**Technical memorandum for an application for subdivision consent under the Resource Management Act 1991 in respect of 42 Okura Road, Elsthorpe**

<b>Applicant's name:</b>	SR&BJ Williams Charitable Trust Board ( <b>Applicant</b> )
<b>Application number:</b>	RM230016
<b>Activity type:</b>	Eleven lot fee simple rural subdivision (8 Rural Lifestyle Lots)
<b>Site address:</b>	42 Okura Road, Elsthorpe, , legally described as Lot 2 DP 481291 (RT 674477) ( <b>Property</b> )

Figure 1: Subdivision Scheme Plan

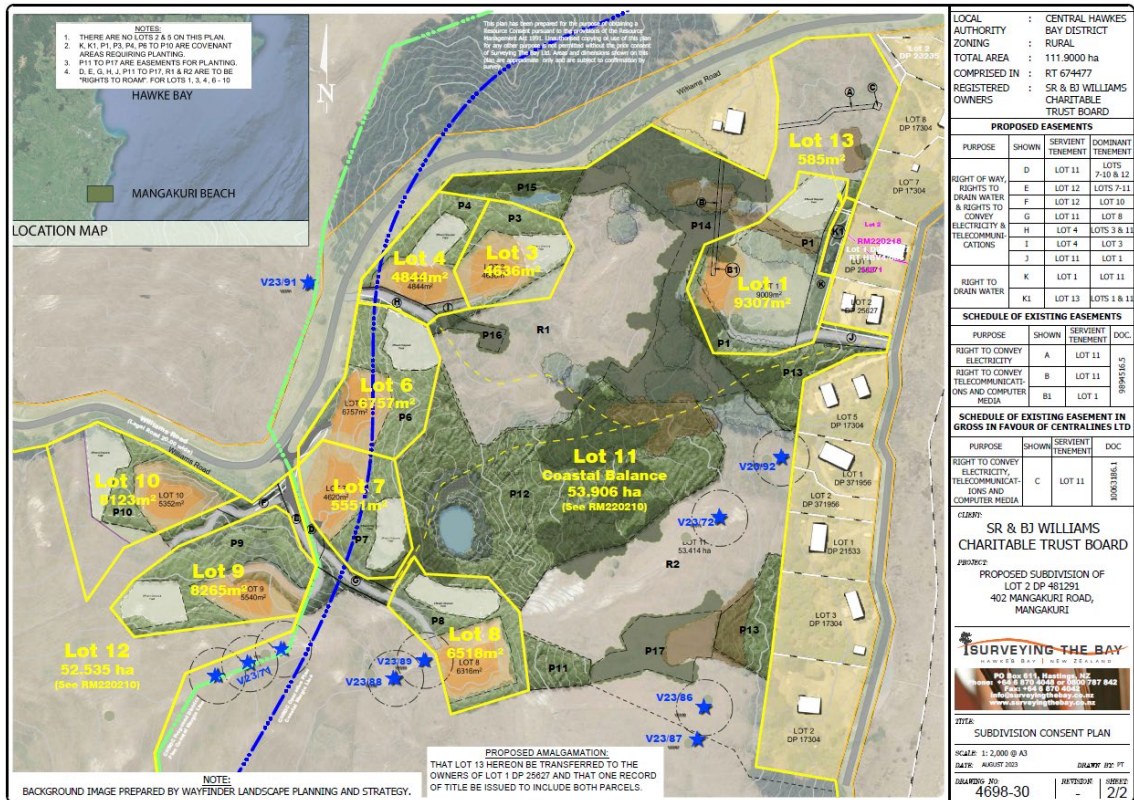
- 5.4. From a transport perspective, the subdivision requires construction of two new crossings to Williams Road, one providing access to Lots 3 and 4 with the other providing access to Lots 6-10. Lot 1 will have access to Okura Road. Property access is proposed via two Right of Way (ROWS) from the new crossings.

- 9.1. I completed a review of the subdivision plans in March 2023. The applicant has provided a response to comments raised in that review and has also updated the subdivision plans. The primary concern raised was in relation to the available sight distances at the new crossings.

- 9.2. The response proposes some minor works would be required to provide an acceptable sight distance on Okura Road. This is accepted and I recommend that the works form a requirement under a condition of consent.
- 9.3. The speed surveys on Williams Road indicate that the 85<sup>th</sup> percentile speeds are well below the speed limit. On that basis, I accept that provision of a sight distance that meets the Austroads requirements for a 50 km/h, that is 97 metres, is appropriate. The transport response recommends removal of trees to achieve this requirement. I recommend that the works form a requirement under a condition of consent.

11.13. The engineering plans indicate that the ROWs have widths as narrow as 3 metres (Lots 6, 8 and 10) which could affect the ability of FENZ to respond to an emergency. In my opinion, all accessways should be constructed to a minimum formed width of 3.5 metres unless the Applicant can demonstrate that a reduced width is sufficient to accommodate the vehicle tracking of a fire appliance. This would address the FENZ submission (#24).

- c. The Applicant shall implement any necessary works to achieve a minimum sight distance of 97 metres from the new crossings on Williams Road.
  - d. All accessways shall be formed to a minimum width of 3.5 metres. Seal widening shall be provided at curves as necessary to ensure that an 8 metre long fire appliance can travel along the accessway without leaving the carriageway.
